INTERNAL MEMORANDUM

Memo number: 4

SUBJECT: P/24/0173 | Discharge of [conditions 4 \(Landscaping Scheme\)](#), [6 \(Landscape Ecological Management Plan\)](#), [7 \(Play Facilities\)](#), [10 \(Lighting Scheme\)](#), [12 \(Material Finishes\)](#), [16 \(Electric Vehicle Charging\)](#), [19 \(Retaining Works\)](#) and [24 \(Drainage Scheme\)](#) of planning permission P/23/0053 | Dragon Parc Abercanaid Merthyr Tydfil

Documents 4 and 5 (*Condition 10*)

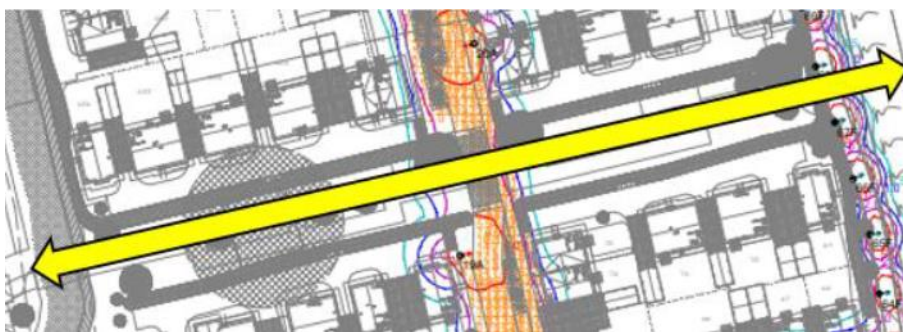
Therefore, rather than 0.5 lux, light levels for dark corridors and sensitive ecological areas (... “in particular **the River Taff corridor, all retained vegetation surrounding the site, and the proposed new SuDS pond to the south**”) must not exceed 0.2 lux on the horizontal plane and 0.4 on the vertical plane. *NB the surrounding vegetation and SuDS pond area still has lux levels that are too high.*

In addition, the dark (west-east) corridor running through the centre of the site has an illuminated barrier running north – south (both centrally and along the path to the east – see lux contours on the plan below). **The lighting must be modified in this area to produce a dark route** through the centre of the site (as depicted by the yellow arrow below).

The horizontal illuminance plan (Document 5) now shows contours down to 0.2lux. The illuminance plans must demonstrate those areas to be kept dark.
